AGENDA

PLANNING AND ZONING COMMISSION MEETING
CITY HALL, 385 SOUTH GOLIAD, ROCKWALL, TEXAS
APRIL 12, 2022 IN THE CITY COUNCIL CHAMBERS AT 6:00 PM

PLANNING AND ZONING COMMISSION CASE MEMO

Exhibit 'B':
Residential Plot Plan

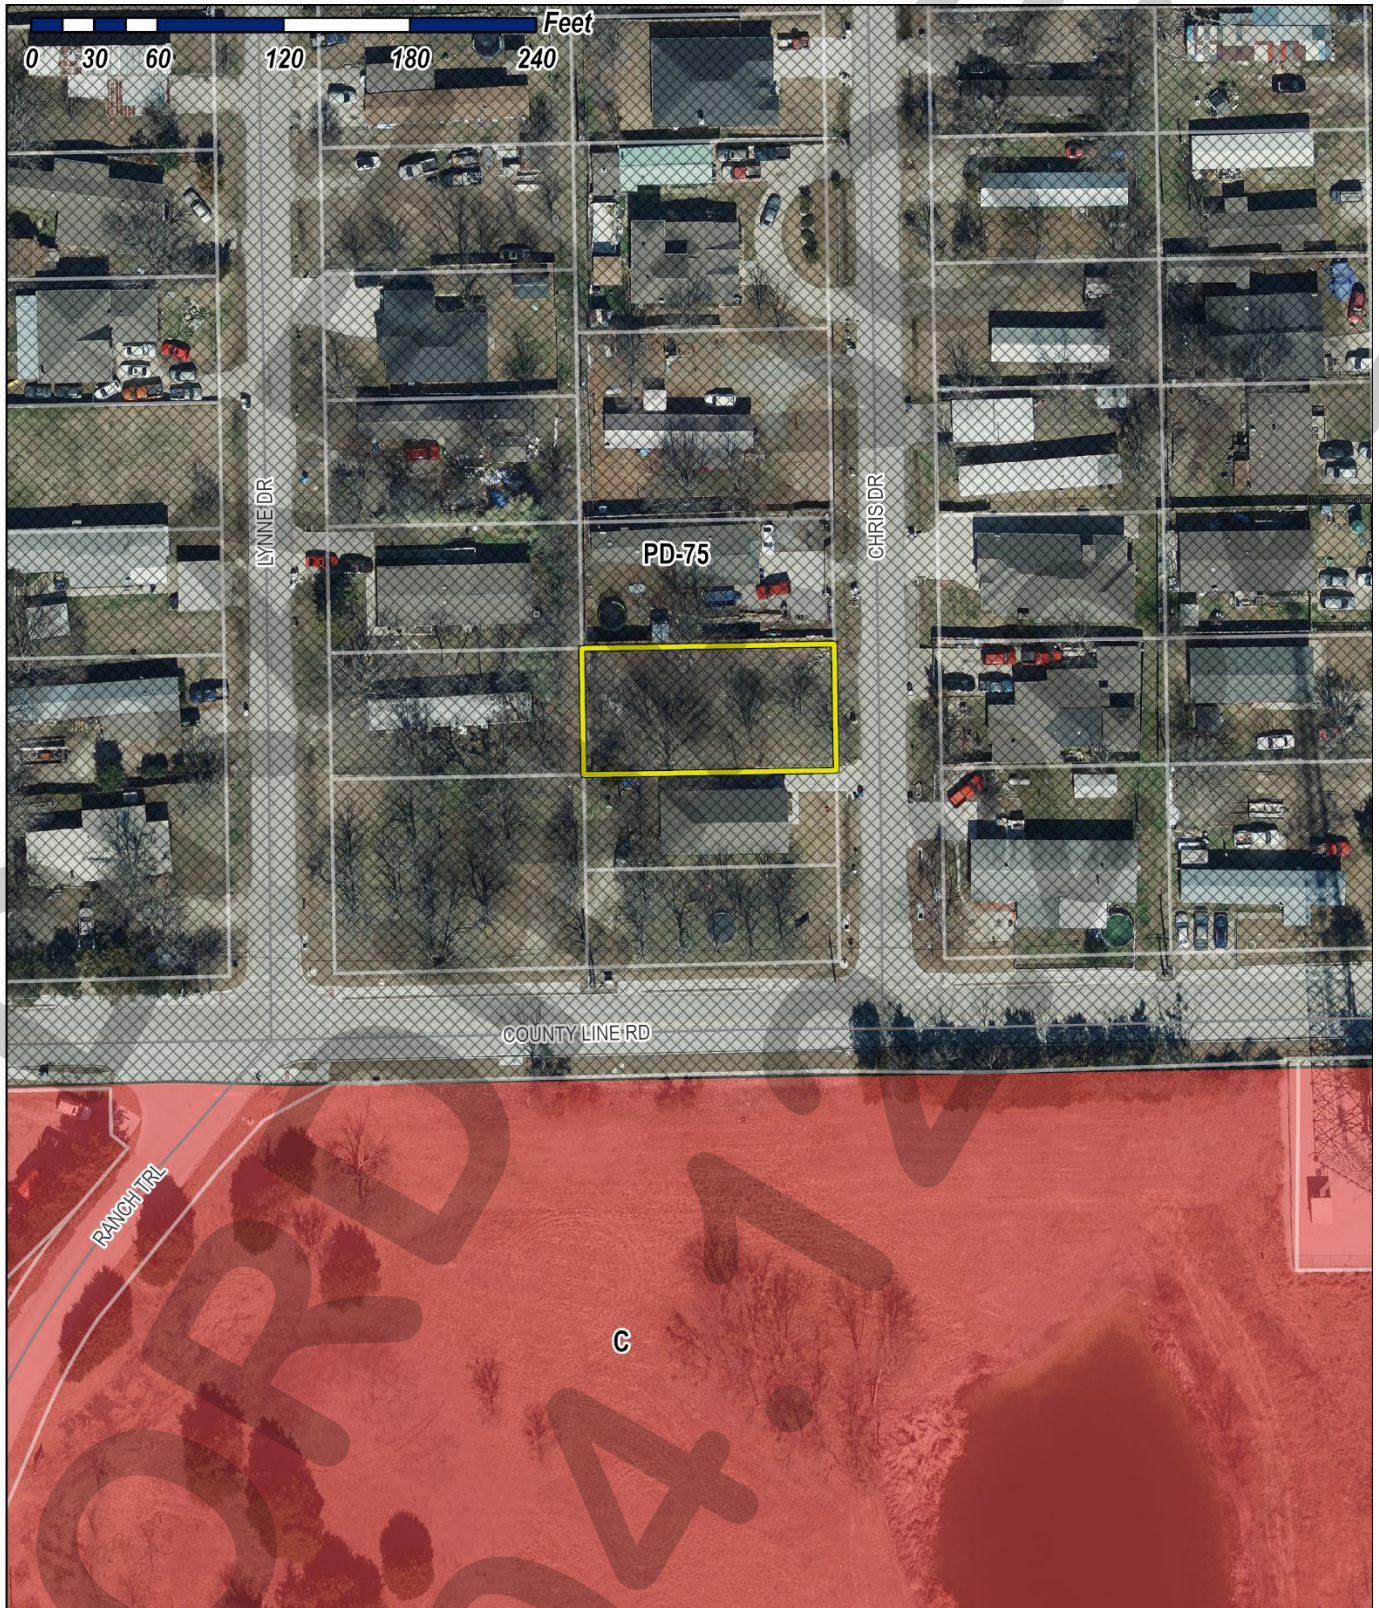
According to Section 04, *Residential Parking*, of Article 06, *Parking and Loading*, of the Unified Development Code (UDC), “(i)n single-family or duplex districts, parking garages must be located at least 20-feet behind the front façade for front entry garages ...” In this case, the applicant is proposing to put the garage approximately six (6) feet, six (6) inches in front of the front façade of the home, and if approved the Planning and Zoning Commission and City Council will be waiving this requirement. Staff should note that this waiver has been approved in the Lake Rockwall Estates Subdivision in previous cases.

With the exception of the garage setback requirements, the proposed single-family home meets all of the density and dimensional requirements for the Single-Family 7 (SF-7) District as stipulated by Planned Development District 75 (PD-75) and the Unified Development Code (UDC). For the purpose of comparing the proposed single-family home to the existing single-family housing located adjacent to or in the vicinity of the subject property, staff has provided photos of the properties along Chris Drive. The proposed building elevations have also been provided in the attached packet. The approval of this request is

- (a) Development of the *Subject Property* shall generally conform to the Residential Plot Plan as depicted in *Exhibit 'B'* of the draft ordinance.
 - (b) Construction of a single-family home on the *Subject Property* shall generally conform to the Building Elevations depicted in *Exhibit 'C'* of the draft ordinance; and,

Exhibit 'C':
Building Elevations

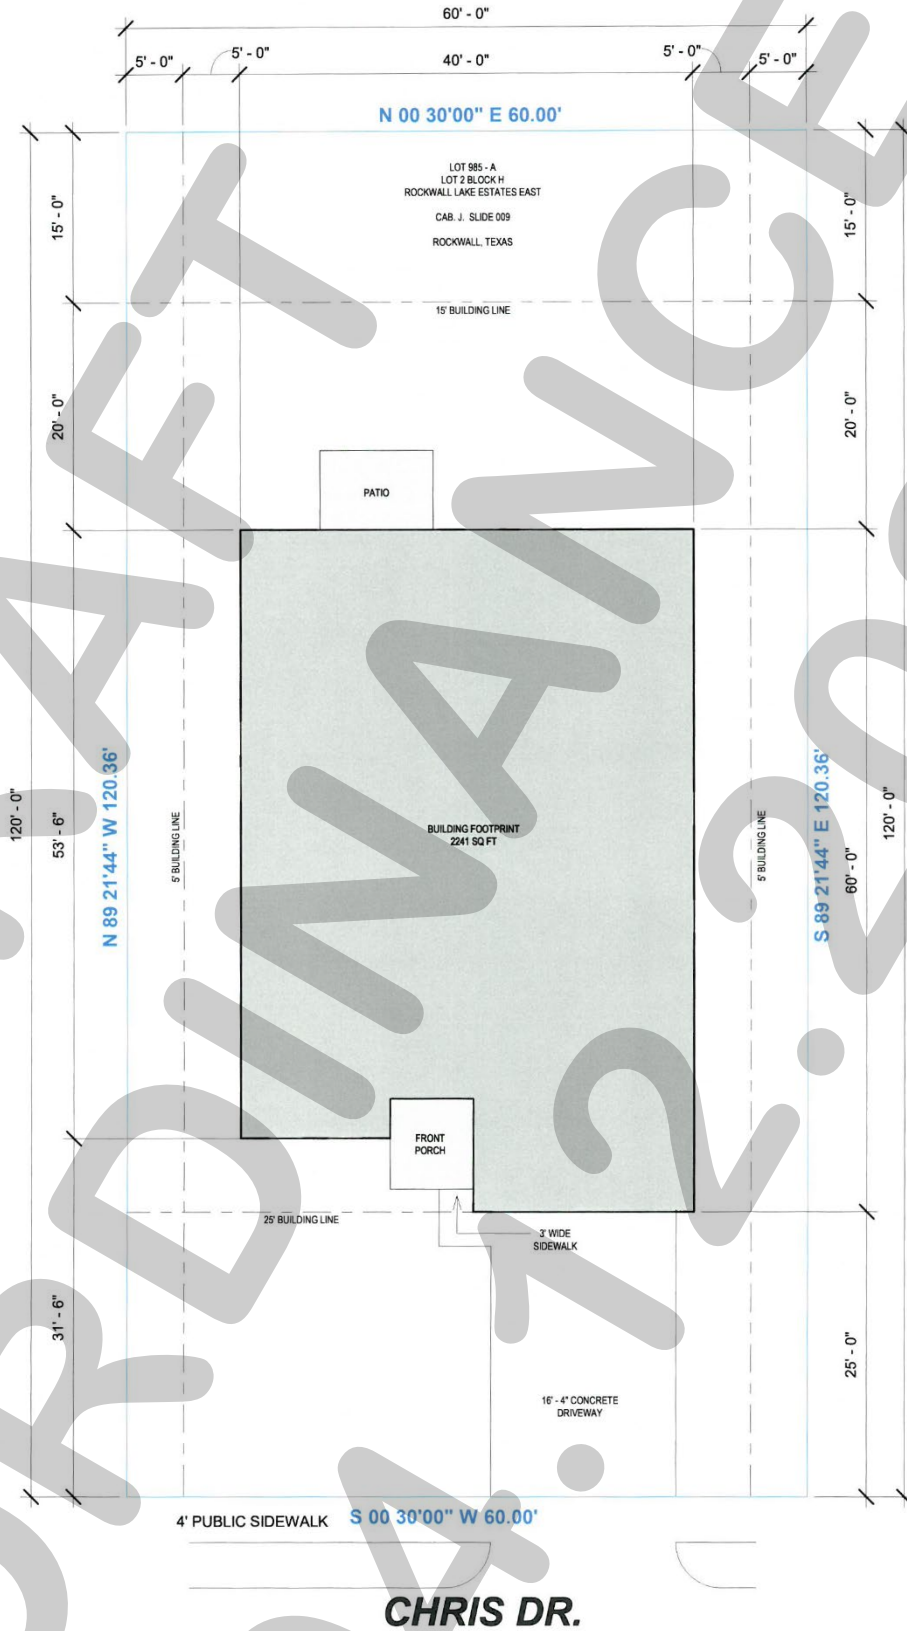
In addition, Subsection 02.03(B)(11) of Article 04, *Permissible Uses*, of the UDC states that, “...the Planning and Zoning Commission and City Council shall consider the proposed size, location, and architecture of the home compared to the existing housing ... [and] (a)ll housing proposed under this section [*i.e. Residential Infill in or Adjacent to an Established Subdivision*] shall be constructed to be architecturally and visually similar or complimentary to the existing housing ...” The following is a summary of observations concerning the housing on Chris Drive compared to the house proposed by the applicant:

Building "B" Front Elevation, North or South
Scale: 1/8" = 1'-0"

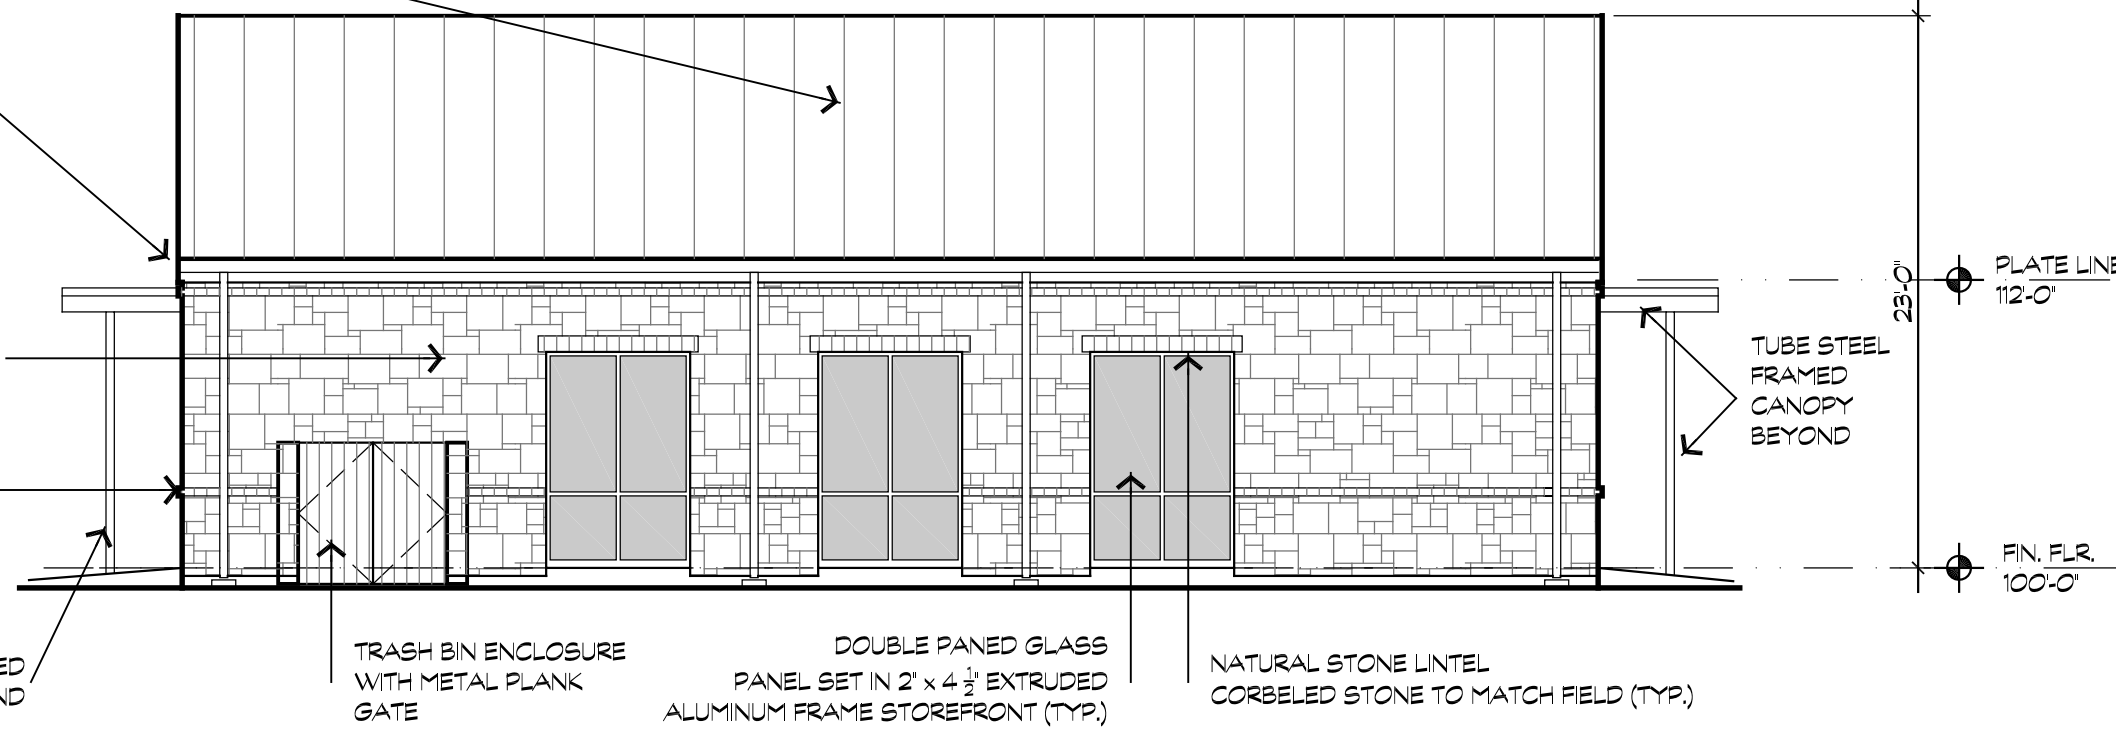
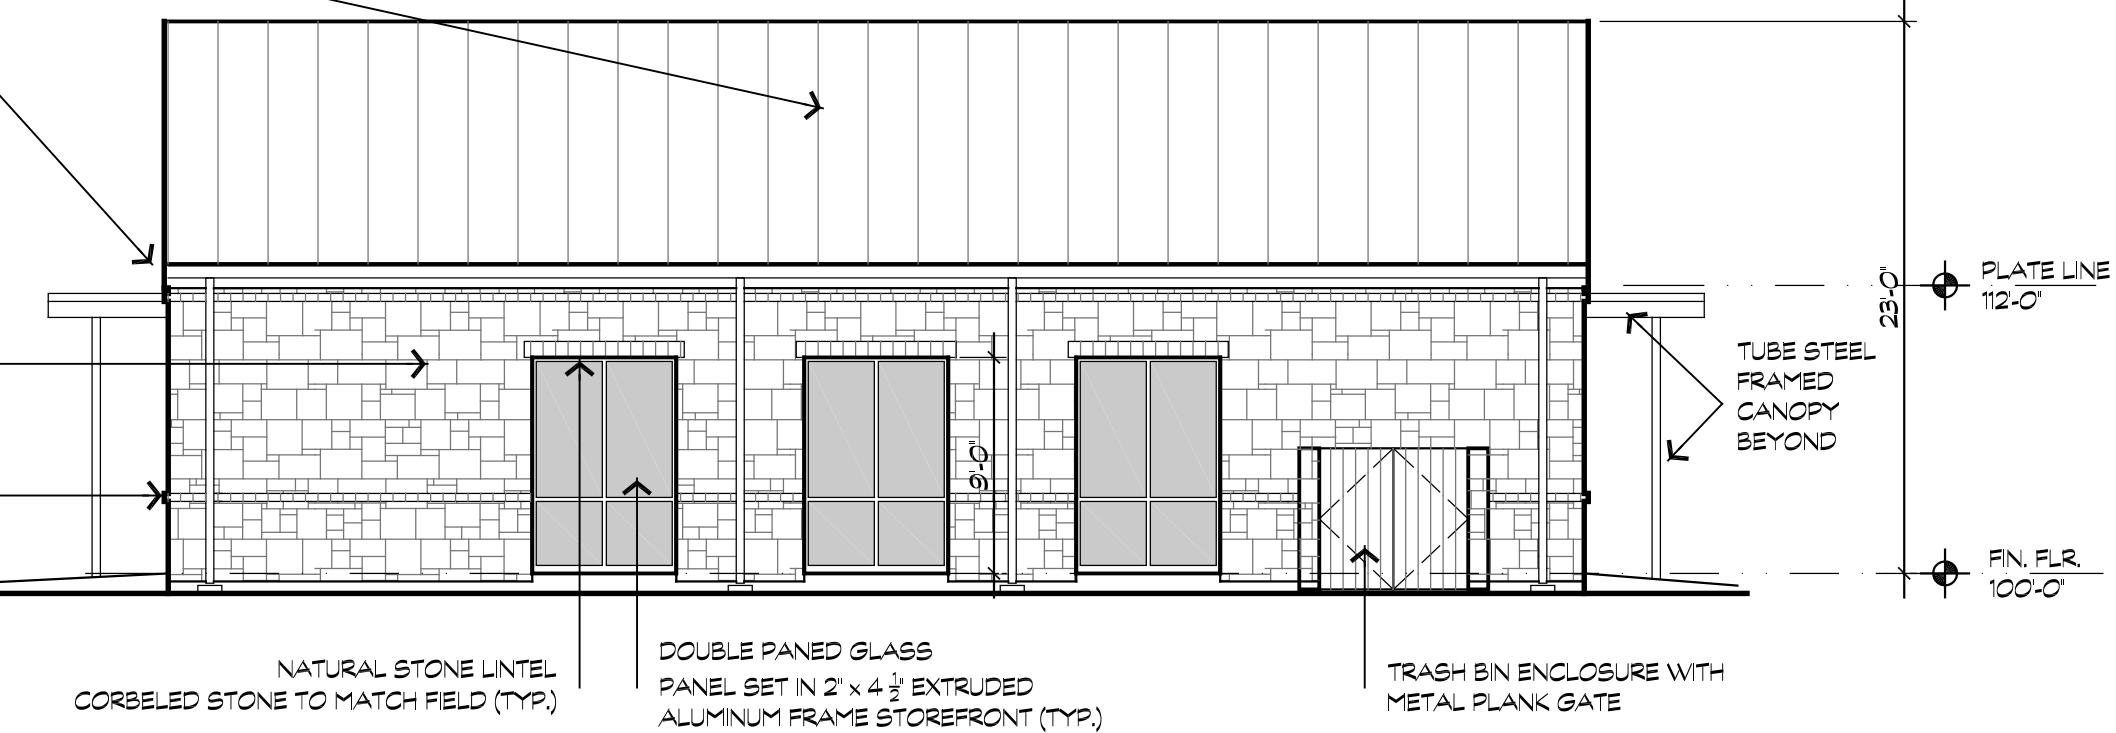
As shown on the building elevations on sheet A3.02 for Building “B” the front and back side of the buildings are do not meet this requirement with a percentage of stone of 84% and 76% respectively with the exclusion of the area for windows and/or doors.

As a compensatory measure to this variance, we are proposing to construct a common area courtyard between each of the Building “B” sites to provide a sense of connectivity throughout the interior of the project site. As another compensatory measure, as can be seen on the landscape plan, various species of trees, shrubbery, and colorful plantings will be installed within the common courtyard areas.
